CGW Ref: 240461-LET-001-A

RE: 240461 – 110 Te Moana Road, Waikanae – Response to Geotechnical Requests For Information – Private Plan Change

SPT Name: CPT04 SLS

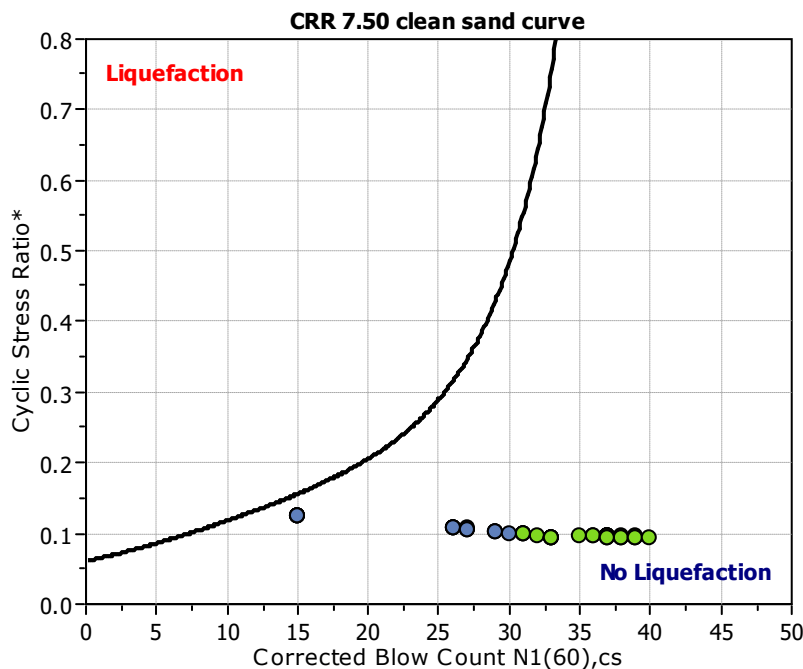
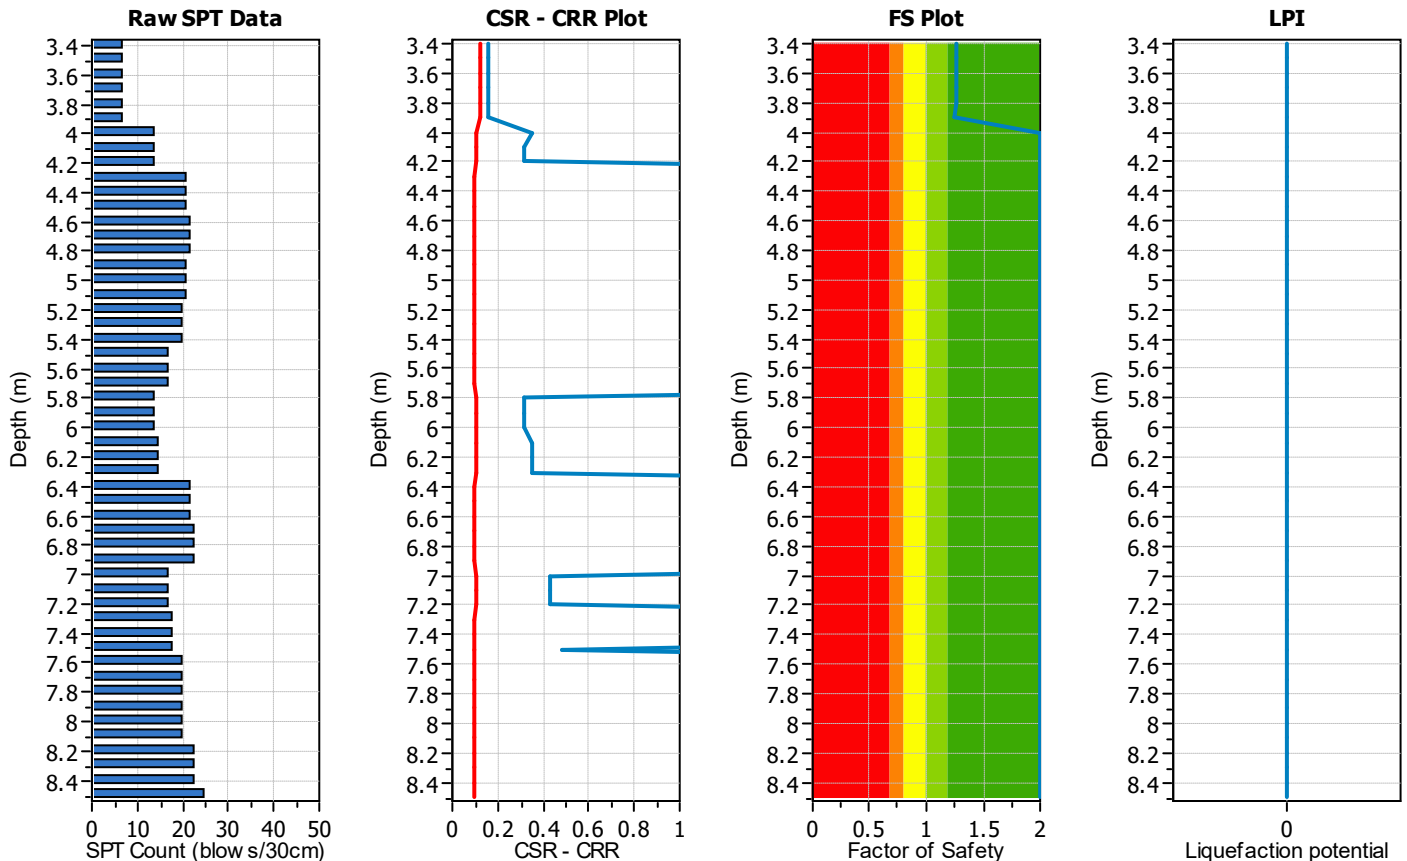
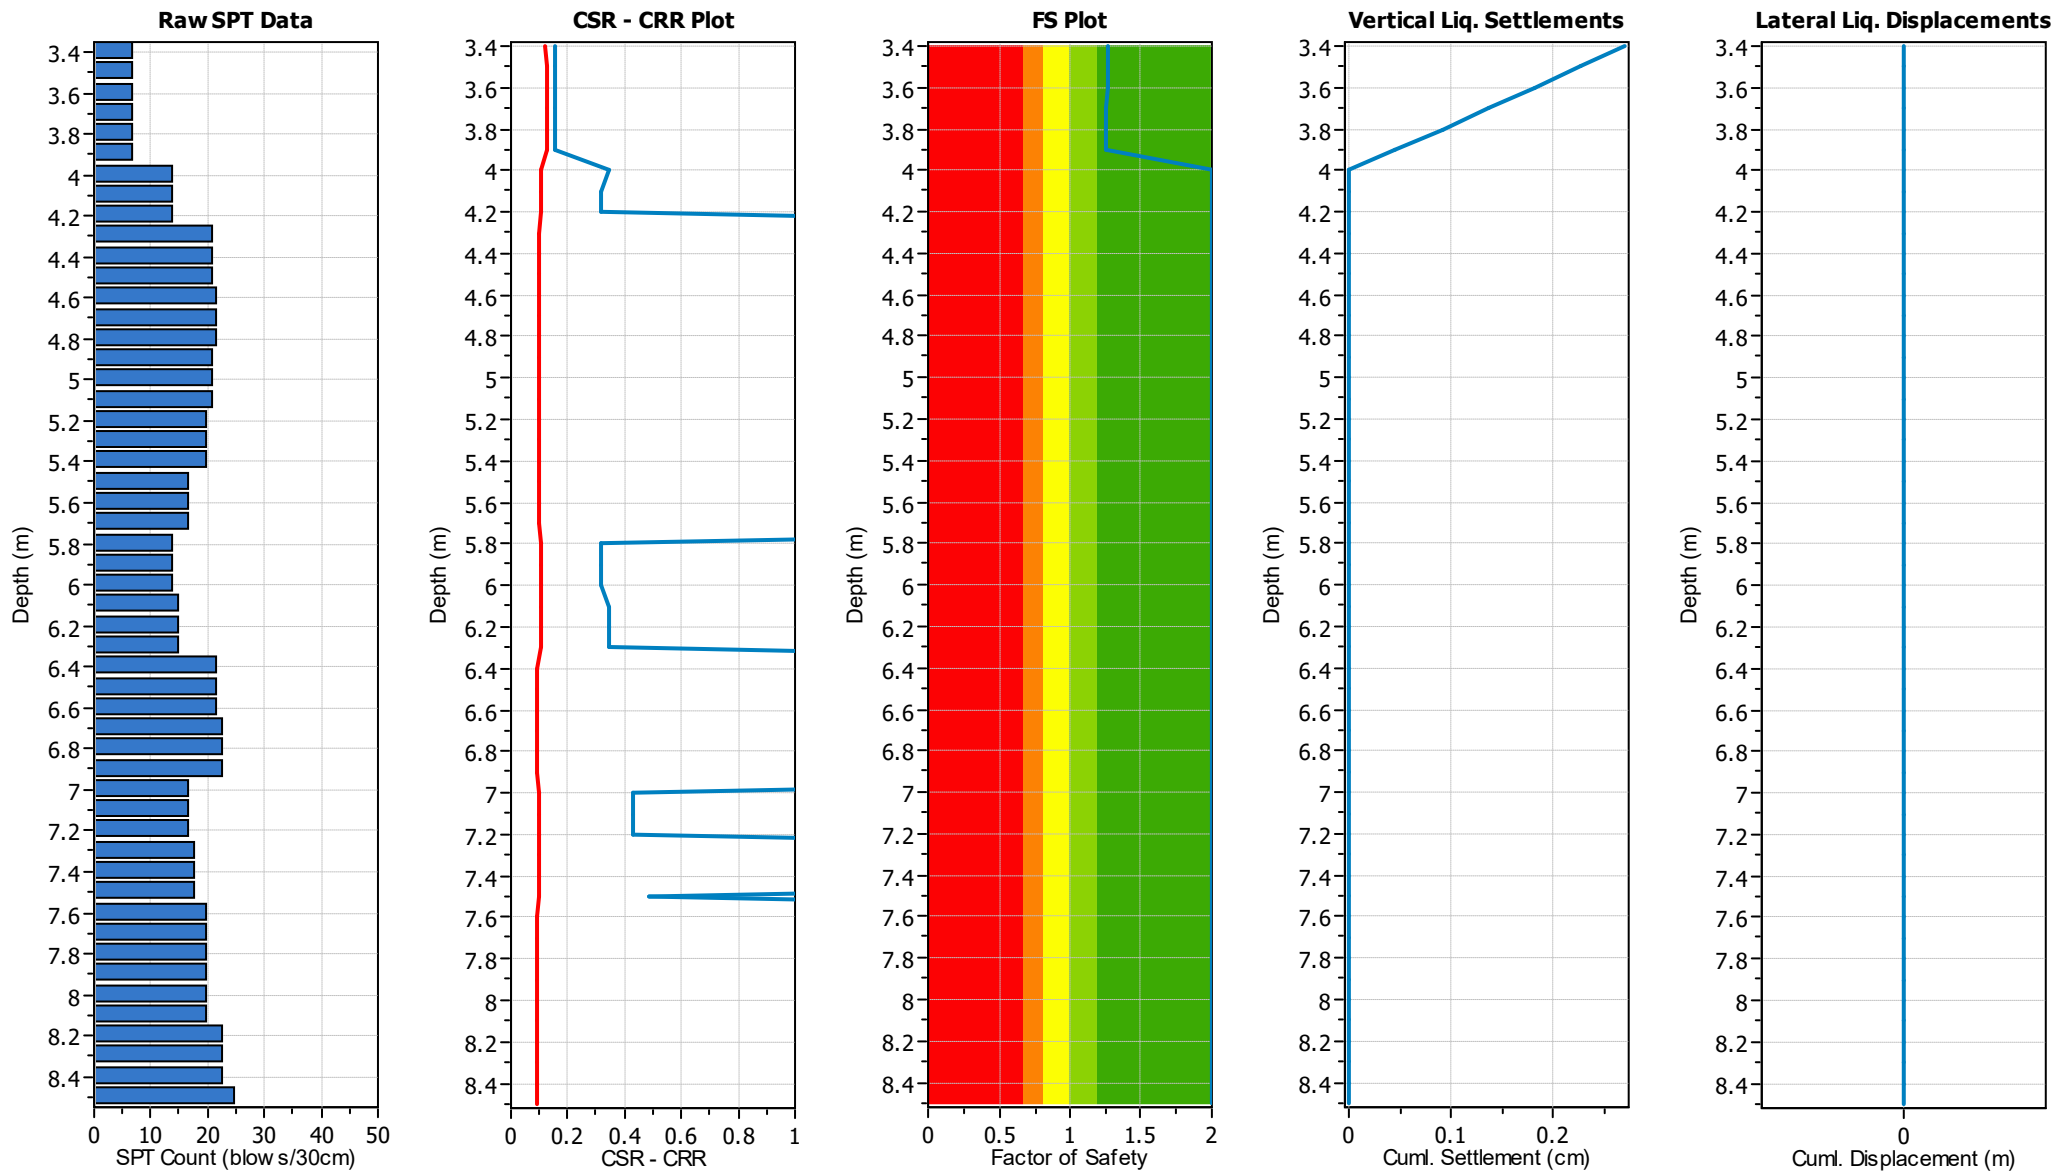
2. *Please clarify if the SPT based liquefaction analysis report attached in Appendix E of the CGW geotechnical report is for CPT04 which was completed in April 2025 as part of the CPT04 (DPSH) 3.2 to 8.6 m.*

We confirm that the SPT-based liquefaction analysis in Appendix E relates to data collected from CPT04, which was completed in April 2025 using DPSH methods from 3.4 m to 8.6 m depth. This was undertaken to supplement the CPT dataset and provide additional insights on liquefaction potential for the low-lying area. The information is factually correct, albeit, mislabelled as CPT01 in our SPT liquefaction analysis. Please find appended to this letter the updated analysis outputs.
